ISO 2768-1 Medium, Ra=3,2µm □ Stamp framed text on surface, height = 4mm. Sharp edges chamfered.		Material GGG40	Heat treat, finish Blue Chromate		Status RELEASED		Dimensions 180x150x100		Block HN-454		Hydnet art nr 416-0001					
Design ★					Drawn OBD		Check GCN		Net. weight 17,8 kg		See drawing 3D01042 & M01043					
			1st angle projection 		Depth 		Title Subplate HN16-S-G11/4"-MPAB-WC				Scale 1:2		Size A3		Created date 2006-02-16	
											Drawing L01044C.icd				Sheet 1(1) Rev. C

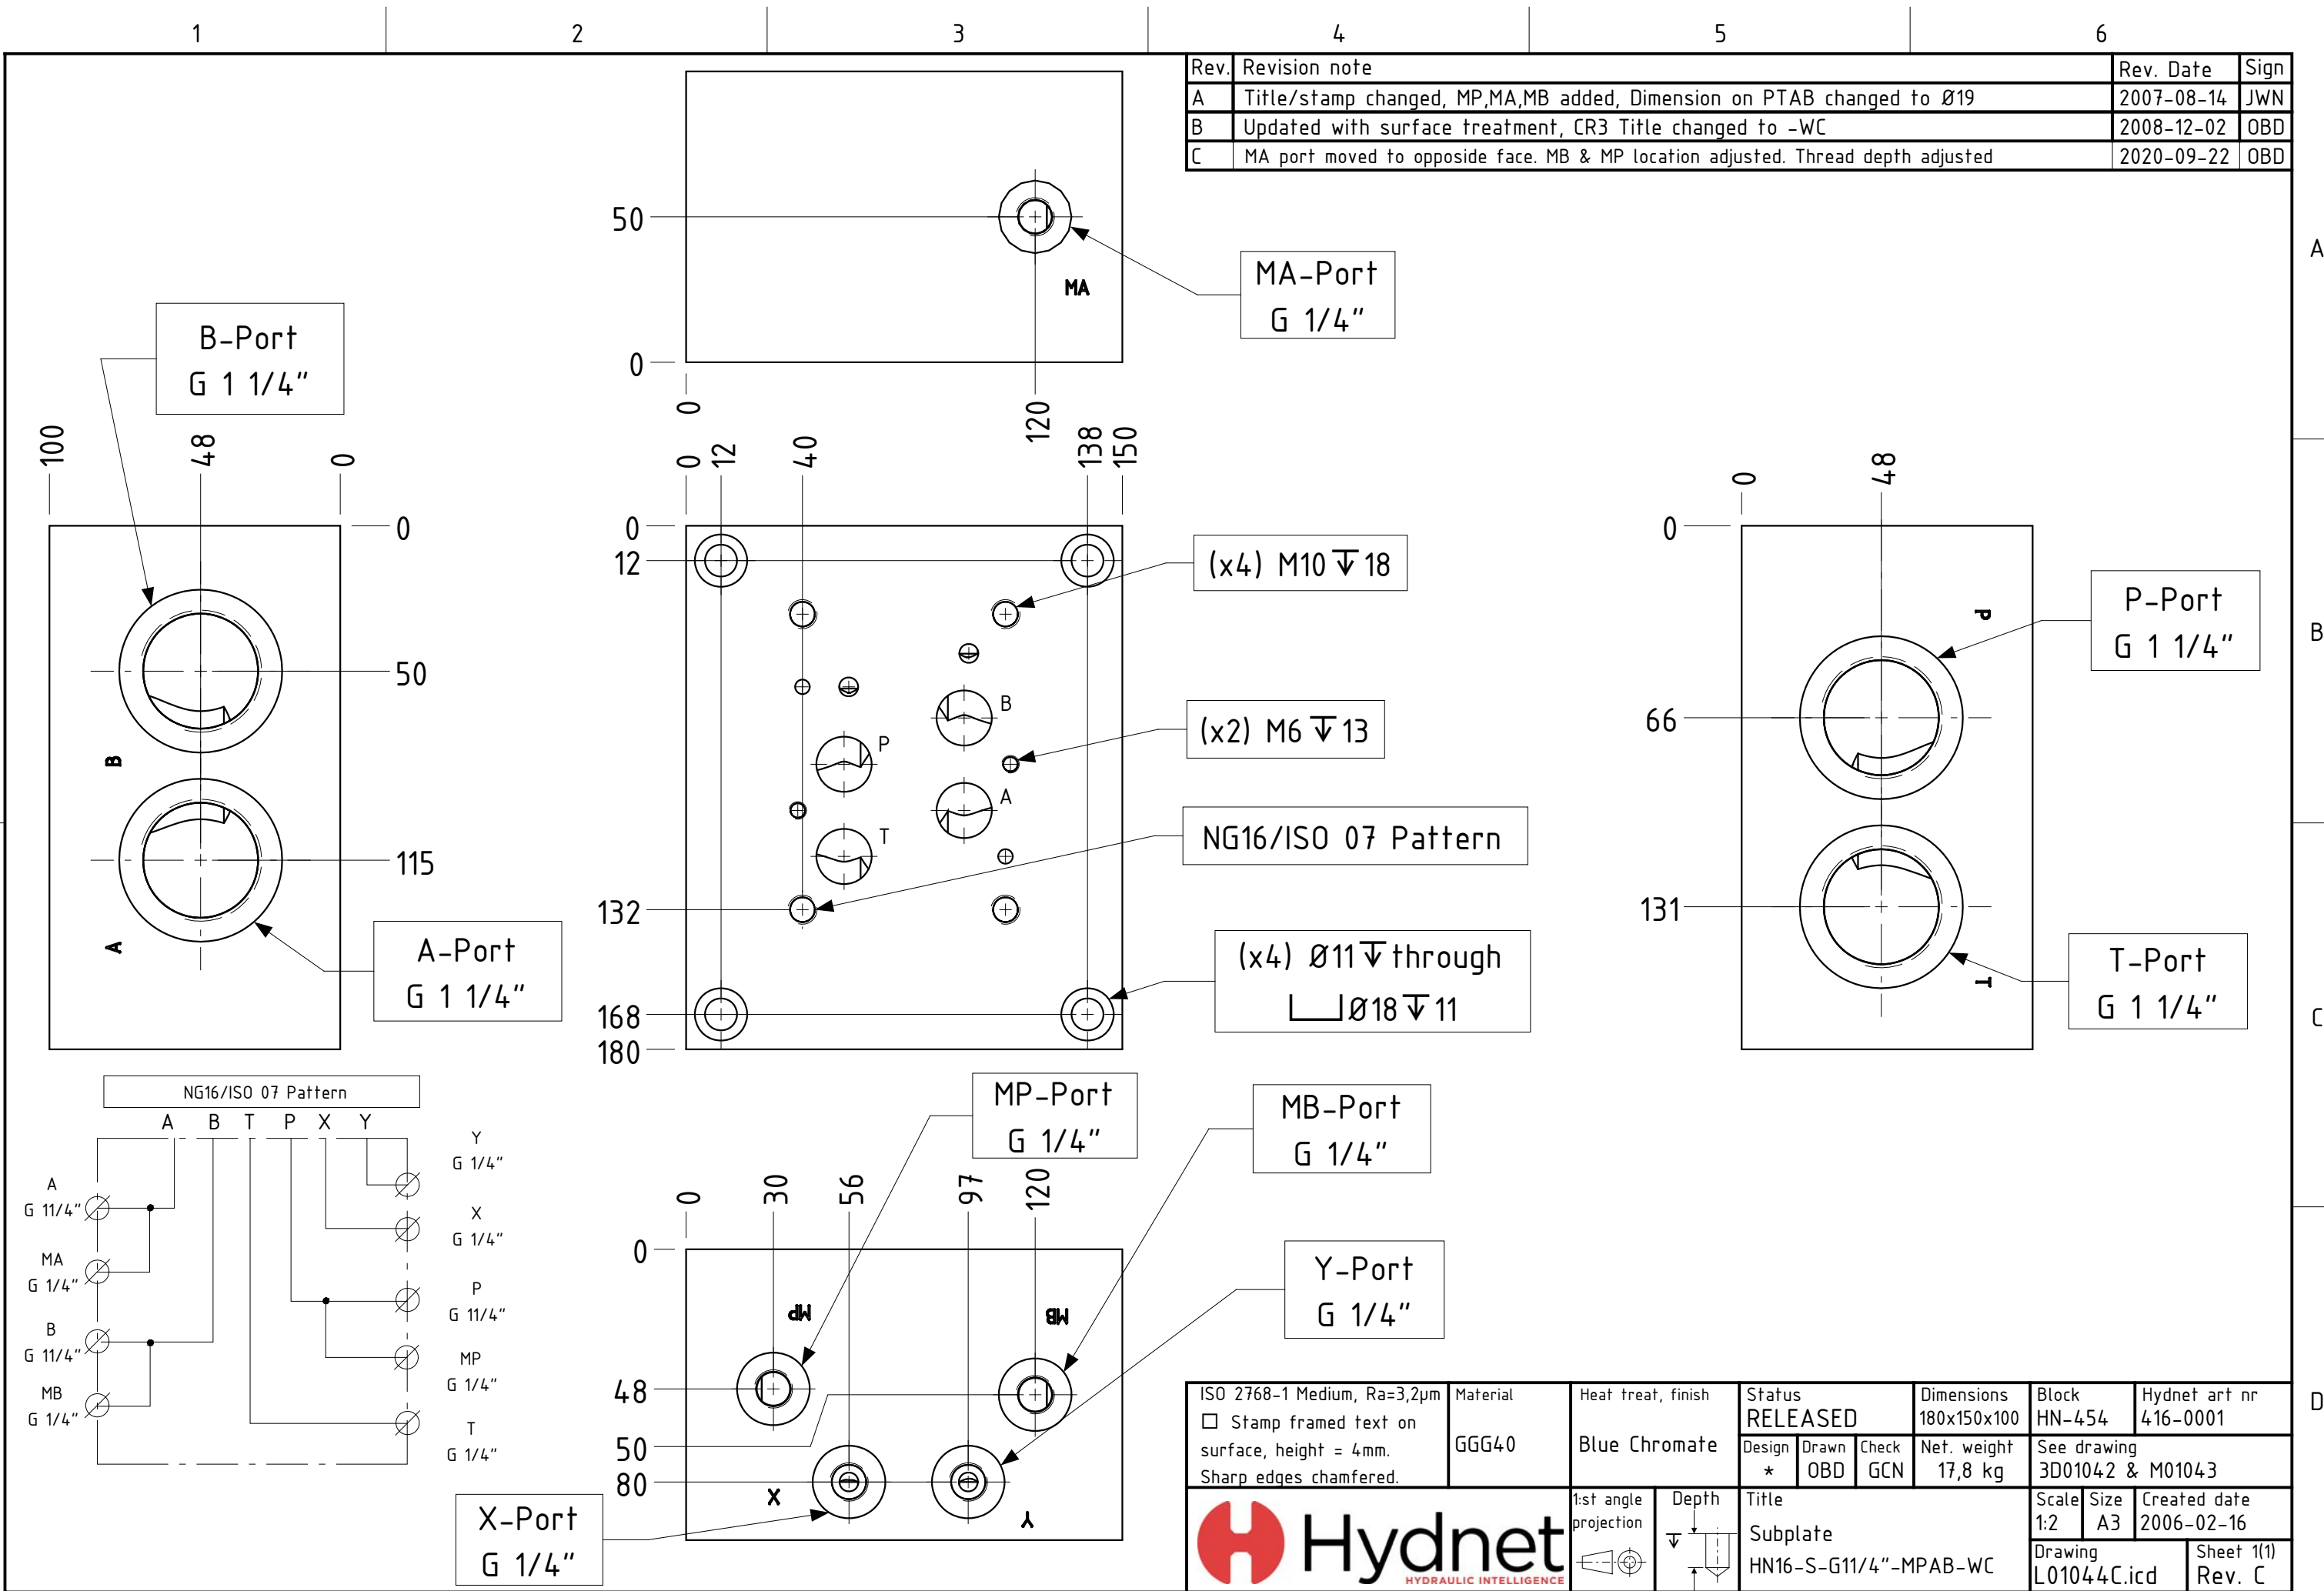
Rev.	Revision note	Rev. Date	Sign
A	Title/stamp changed, MP,MA,MB added, Dimension on PTAB changed to Ø19	2007-08-14	JWN
B	Updated with surface treatment, CR3 Title changed to -WC	2008-12-02	OBD
C	MA port moved to opposite face. MB & MP location adjusted. Thread depth adjusted	2020-09-22	OBD
